## I. Proposal to replace document ECE/TRANS/WP.29/GRBP/2023/11

### I. Proposal

**Example: variation of load capacity highlighted in yellow vs. load index reduction by 2 points**

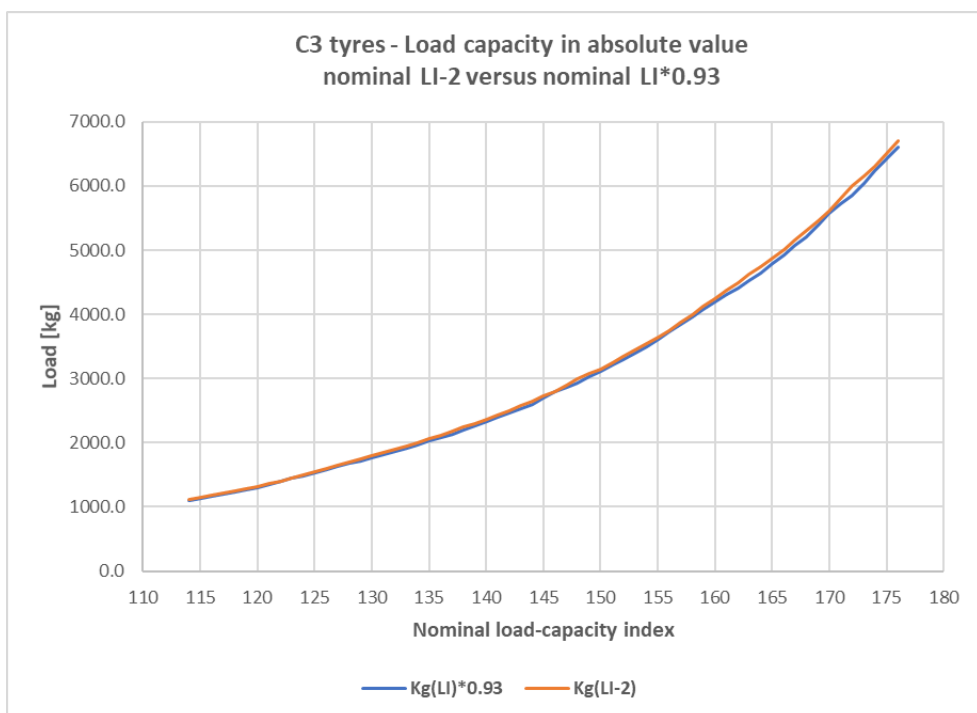
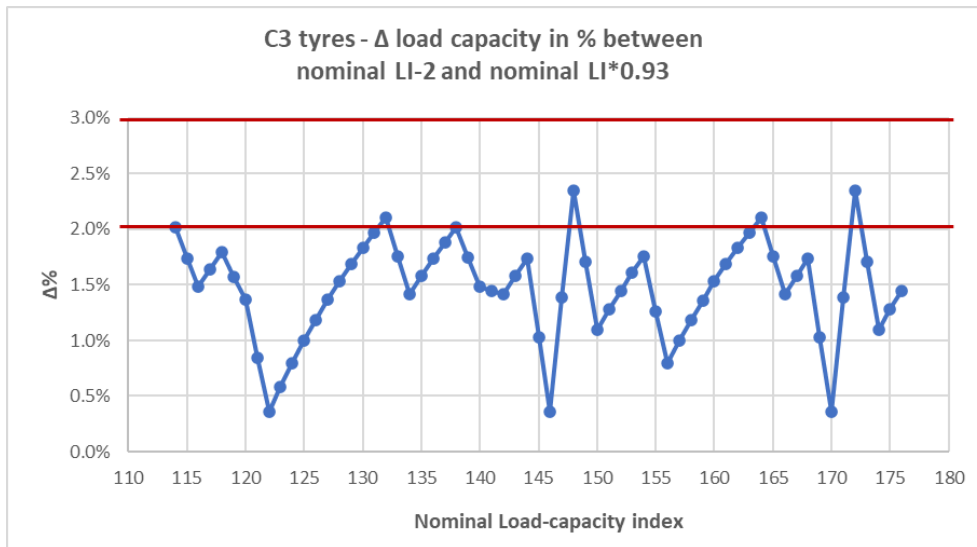
6. In the case of additional service descriptions mentioned in paragraph 6.2.5.1., it is proposed not to perform the additional load/speed test because the load-capacity approximates with a negligible difference the reduction or the increase in percentage of the nominal load/speed combination applicable to the nominal speed category symbol (see Annex 8). **An example of the actual differences (in percentage and in absolute value) is shown in the below diagrams.**
